ADDENDUM NO. 1

To: Bidders
From: Cody Cash, Director of Transportation
Date: 1/21/2025
RE: Improvements to Sampson City Fire Station #90 - Starke

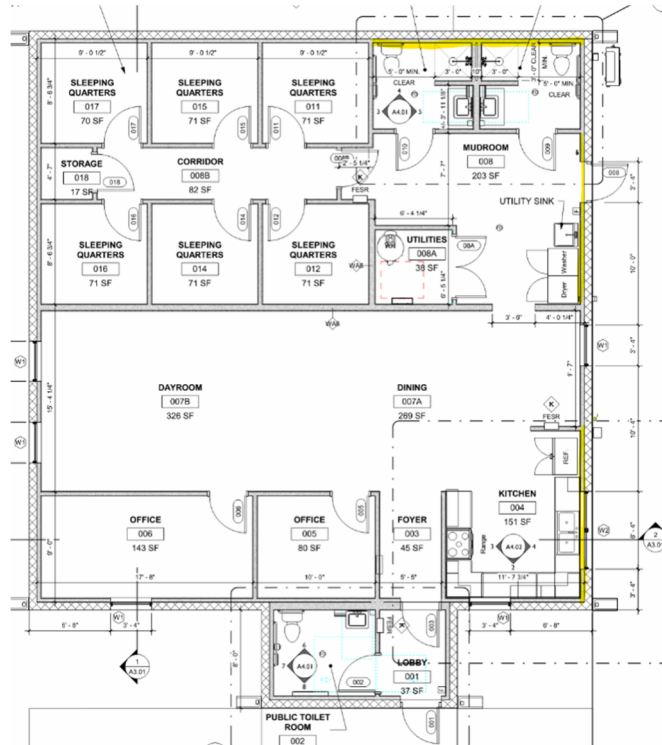
- 7.) Are the 2 exterior doors going to be aluminum store front doors or hollow metal frames and doors?
- **Hollow metal frames and doors.**
- 8.) Are all exterior walls to be full width 2x4s over the block or can furring strip be used to save on cost?
- **If code minimum insulation values can be maintained and in-wall utilities are not affected, it would be acceptable to reduce furring strips in all locations except those highlighted in yellow below.**
